Second Five-Year Review Report

**For
Homestake Mining Company Superfund Site
Cibola County, New Mexico**

September 2006

FIVE-YEAR REVIEW
Homestake Mining Company Superfund Site
EPA ID# NMD007860935
Cibola County, New Mexico

Figure 5 Water Level Elevations, Alluvial Aquifer (Reproduced from Hydro-Engineering 2006)

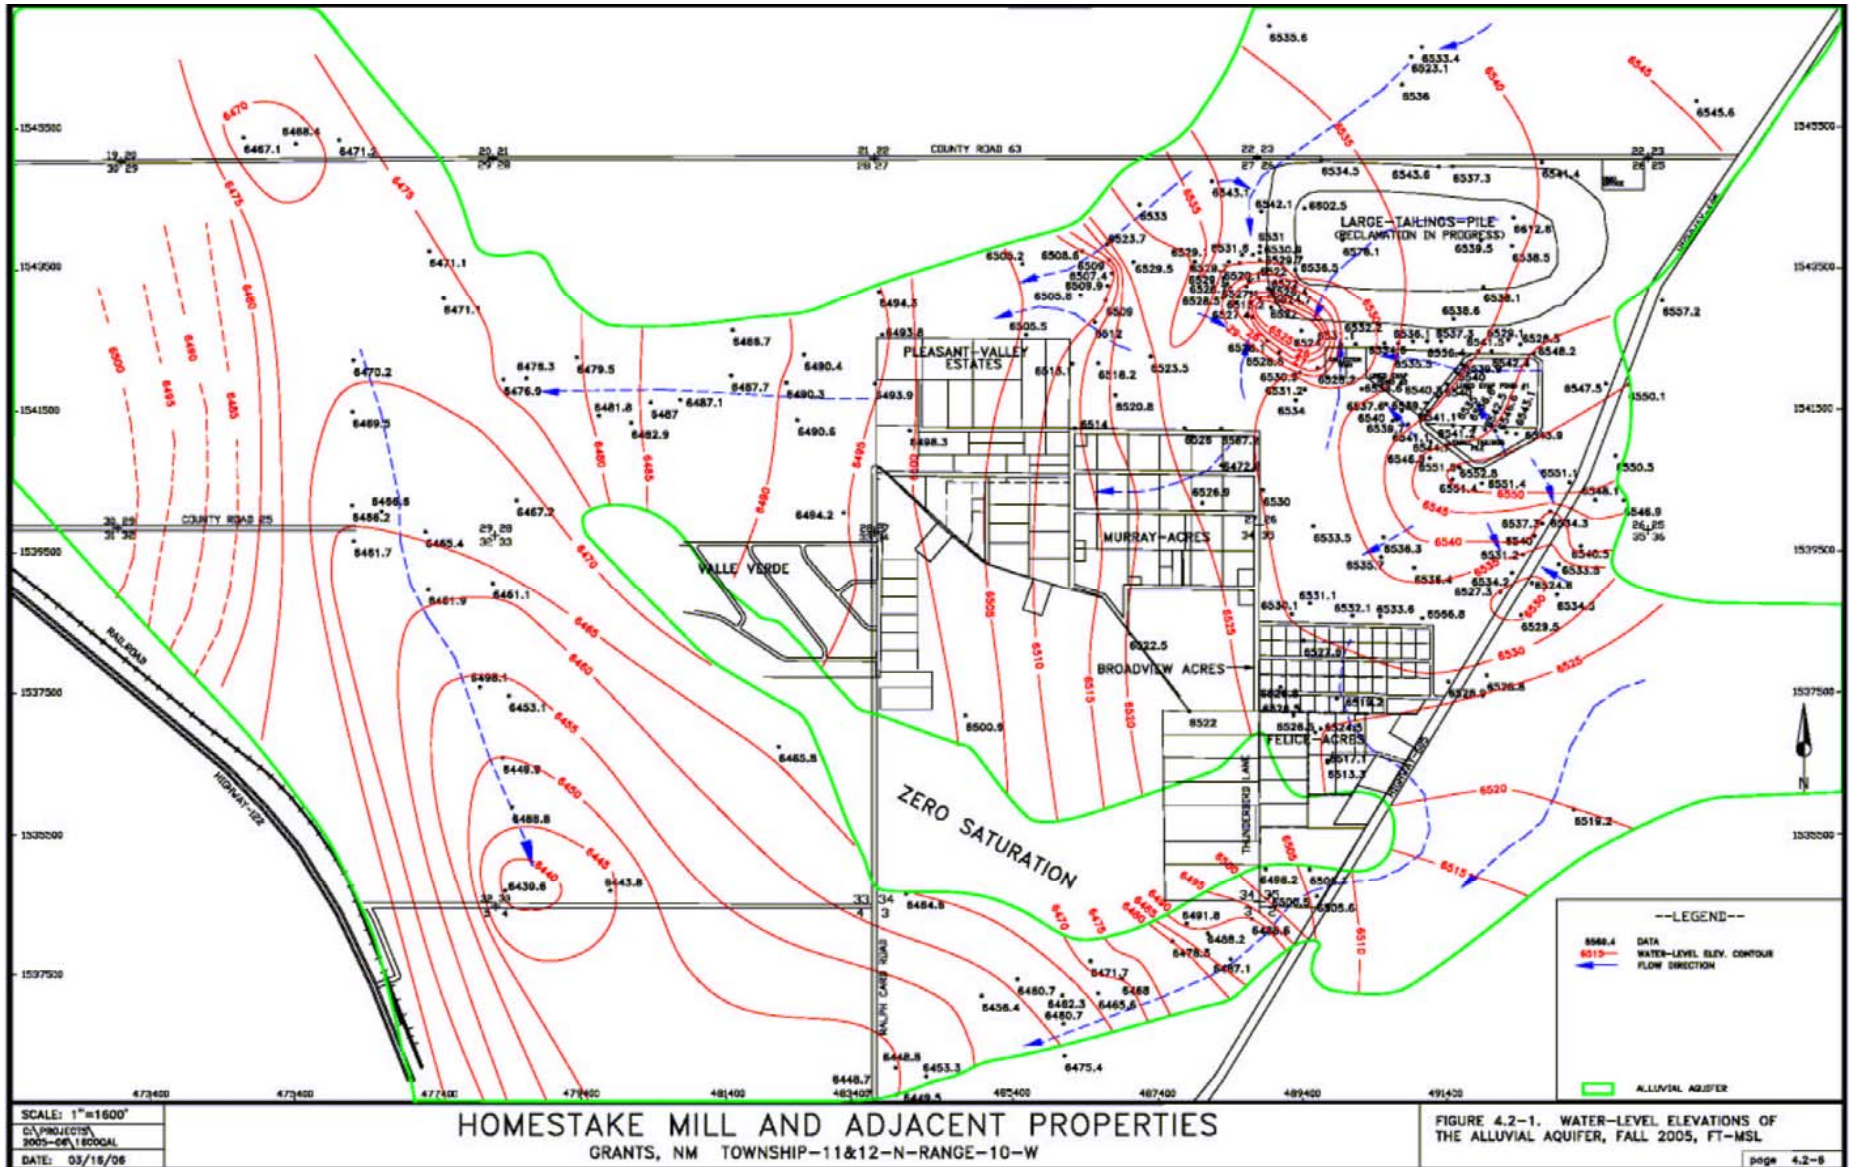
Figure 5 is a contour map of the water elevations in the Fall of 2005 for the San Mateo and Rio San Jose alluvial aquifers. Also shown are areas where the San Mateo alluvium is not saturated. The map shows the effect of ground water collection and injection on the hydraulic gradients and flow directions within the alluvium beneath the mill site. The natural southwest ground water flow direction has been reversed in an area between the tailings impoundments and the northern edge of the Subdivisions, thereby creating a capture zone for recovering contaminated ground water and preventing the further migration of contaminants off the mill site (Hydro-Engineering 2006). Figure 6 shows the locations of monitoring wells in the San Mateo alluvial aquifer used for documenting current ground water quality conditions and trends in contaminant concentrations over time.

Figure 7 Uranium Concentrations of the Alluvial Aquifer (Reproduced from Hydro-Engineering 2006)

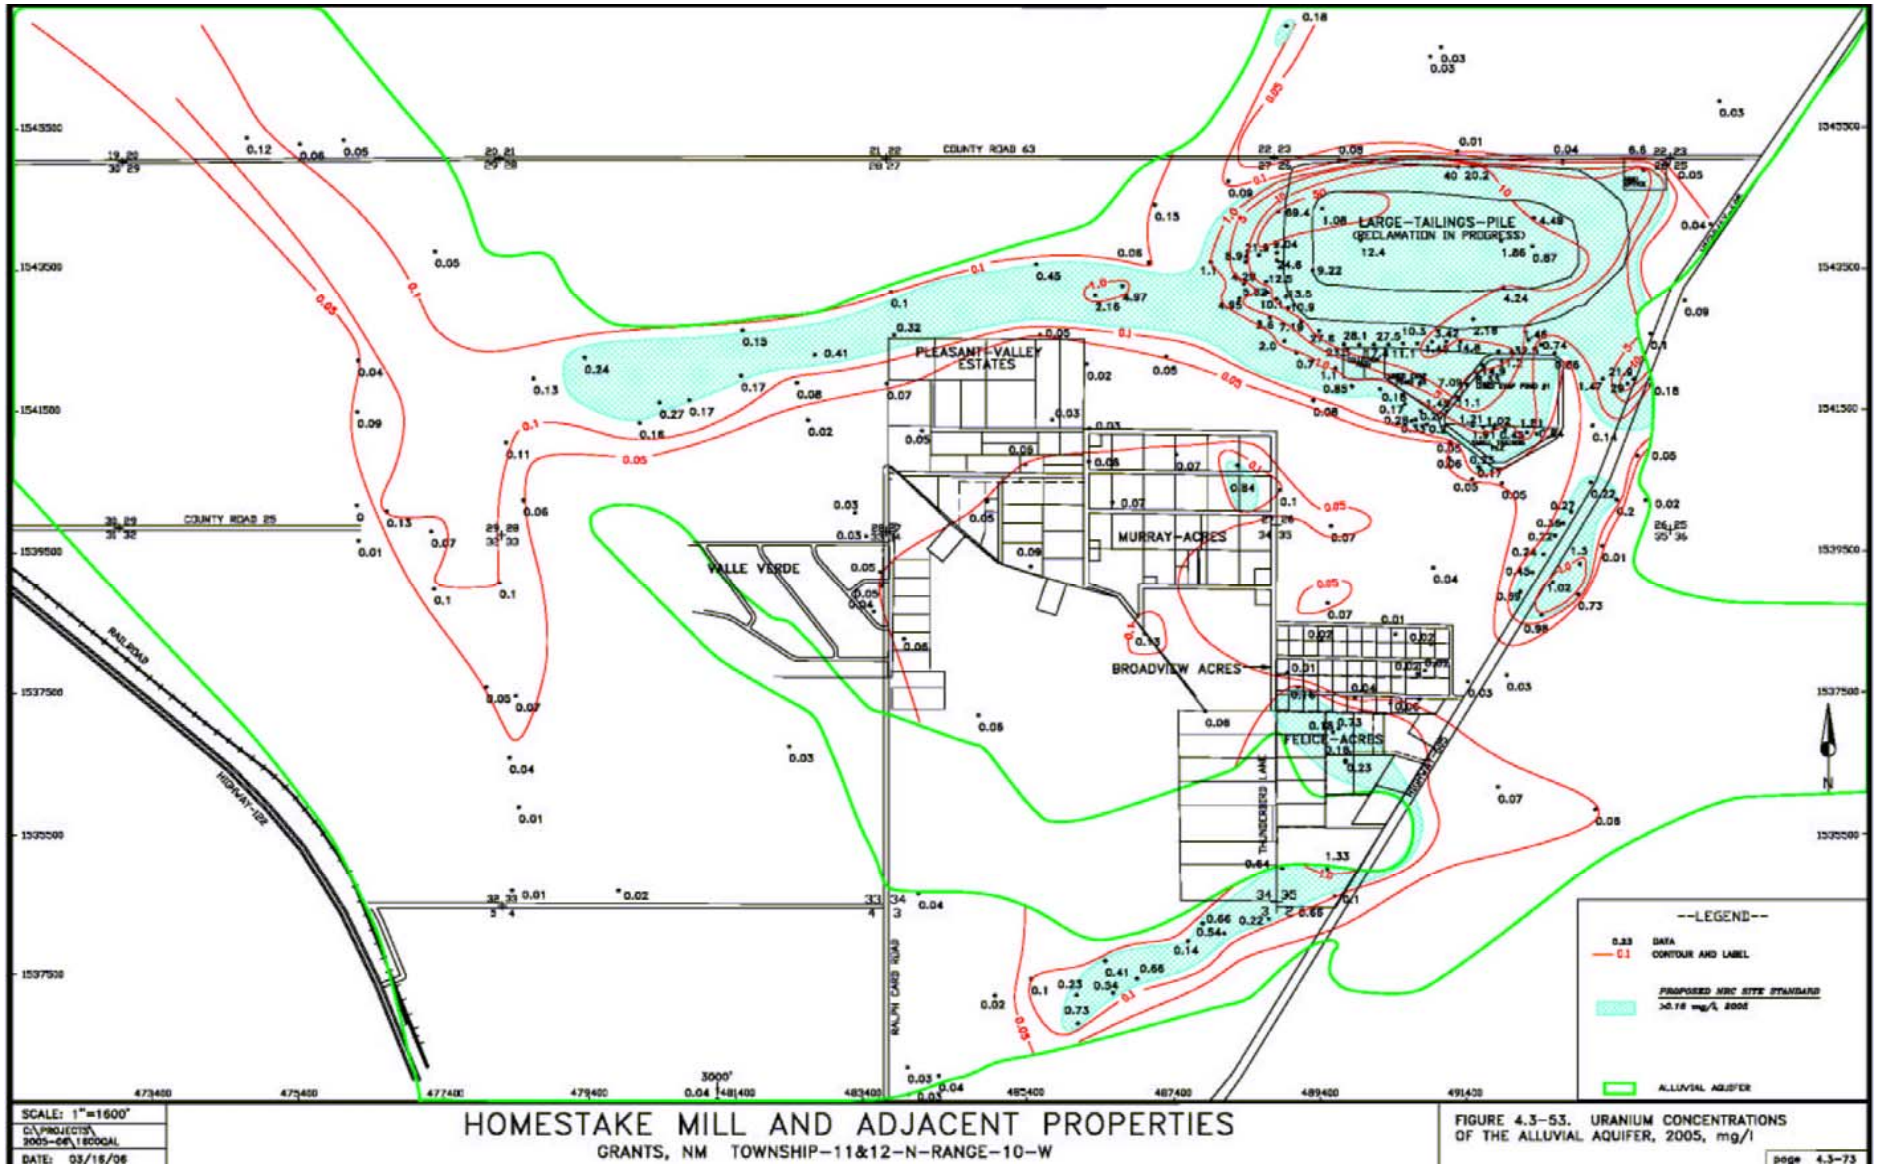
Figure 7 is an iso-concentration map of uranium in the San Mateo alluvial aquifer. The map highlights the locations where uranium concentrations exceed the proposed Site cleanup criterion of 0.16 mg/l that was supported by the NMED and the EPA, and is still awaiting final approval by NRC. The areas of highest uranium concentrations occur beneath or near the tailings impoundments. Two separate, narrow, and elongated uranium plumes extend from the tailings impoundments to the west and south as shown in Figure 7. The uranium plume to the west of the impoundments extends beneath the northern portion of Pleasant Valley Estates subdivision, past Valle Verde. Concentrations decline with distance from the tailings impoundment, with further declines in uranium concentrations where the San Mateo alluvial aquifer joins the Rio San Jose alluvial aquifer. The southward-extending uranium plume appears to originate beneath the east perimeter of the small tailings impoundment and follows Highway 605 past the Broadview Acres and Felice Acres subdivisions. Beyond the Felice Acres subdivision the plume bends toward the west along a separate and constrictive zone as depicted by the alluvial aquifer limits in Figure 7. There is also an isolated area within the Murray Acres subdivision where the uranium levels exceed the proposed background level.

Figure 9 Uranium Concentrations for Well 496 (Reproduced from Hydro-Engineering 2006)

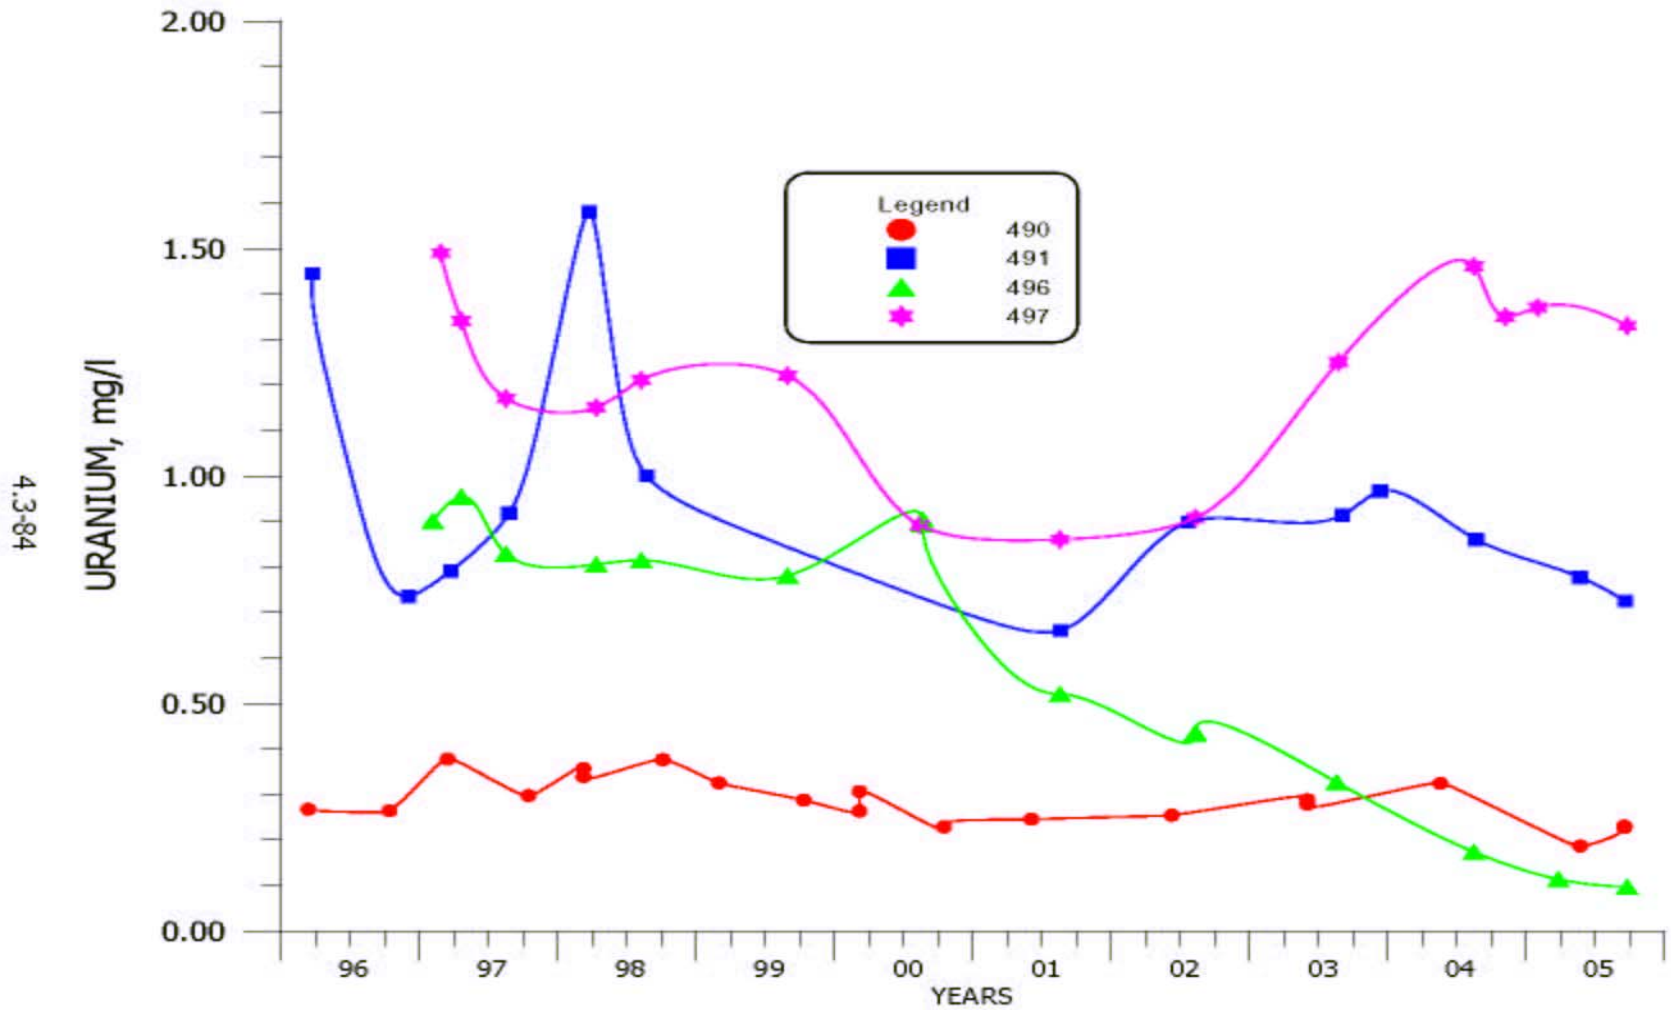
downgradient of the wells 862, 876 and 869. Uranium concentrations in wells upgradient of this segment also show no increasing trends and have actually declined in Well 496 as shown in Figure 9. Furthermore, sulfate, chloride, TDS and selenium concentrations did not show increasing trends in wells 862, 876 and 869. Thus, the increase in uranium concentrations in wells 862, 876 and 869 may not reflect a long-term trend but could be due to changing flow paths resulting from injection and extraction at nearby wells. Additional monitoring of these wells over time will be needed to determine the concentration trend in these wells and in downgradient well 631.

Figure 14 Water Level Elevations of the Upper Chinle Aquifer (Reproduced from Hydro-

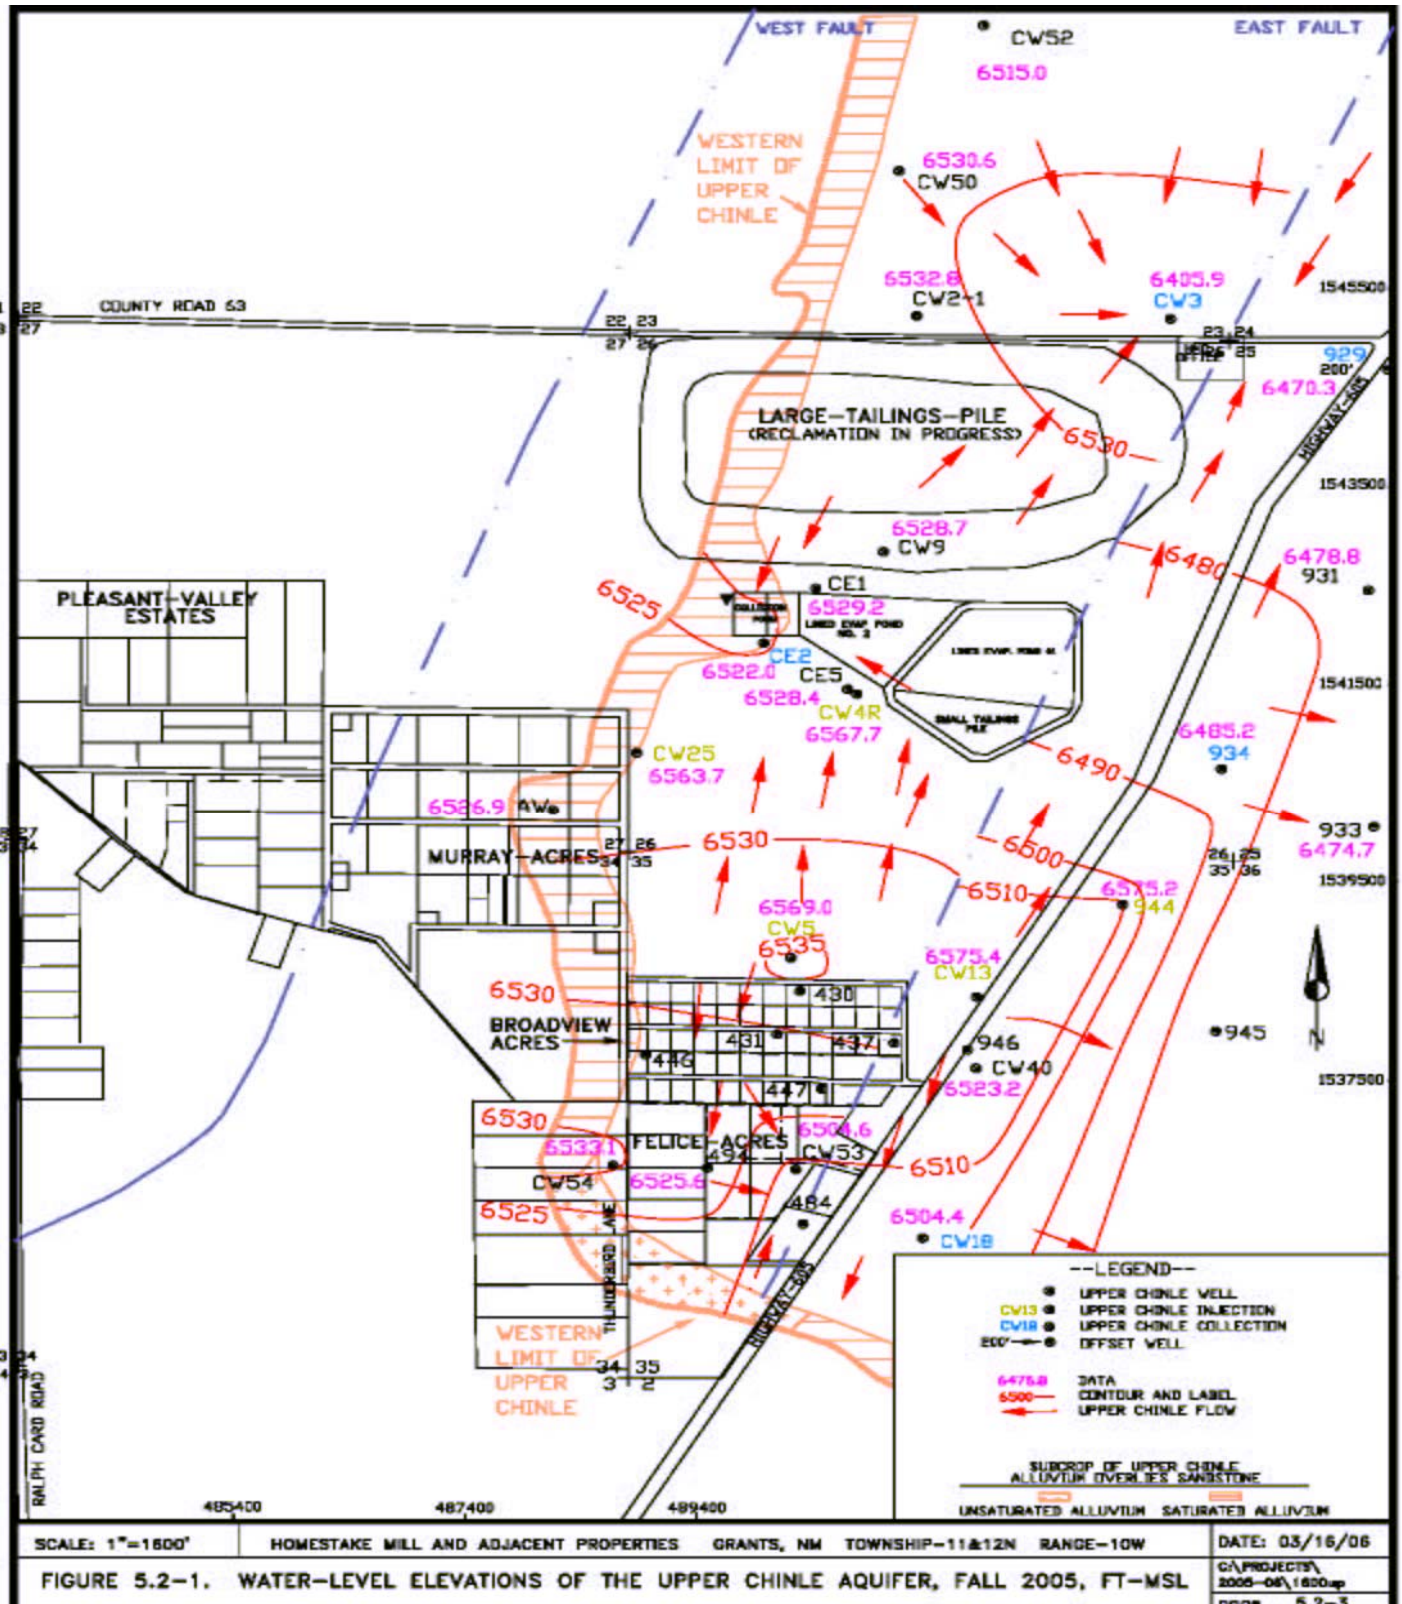
Upper Chinle Aquifer. Figure 14 is a contour map of the water elevations in the Fall of 2005 for the Upper Chinle sandstone. This Figure shows the subcrop of this unit with the alluvium. The Upper Chinle aquifer does not exist to the west and south of the subcrop area. A blue dot pattern is used to show the limits of the Upper Chinle aquifer. This figure also shows the location of the West and East Faults. The blue arrows on Figure 14 show the direction of ground water flow, which is influenced by location of the ground water extraction and fresh-water injection wells shown in the Figure. Upper Chinle wells CW4R, CW5, CW13, CW25 and 944 are shown in cyan blue to denote that these are fresh-water injection wells. Upper Chinle wells CE2, CW3, 929 and 934 were pumped as a source of flushing water for the Large Tailings Pile in 2005 and are shown in orange. Well CW18 is also shown in orange because this well was used as a supply for fresh-water injection starting in late September of 2002 but was not used continuously after May of 2004.
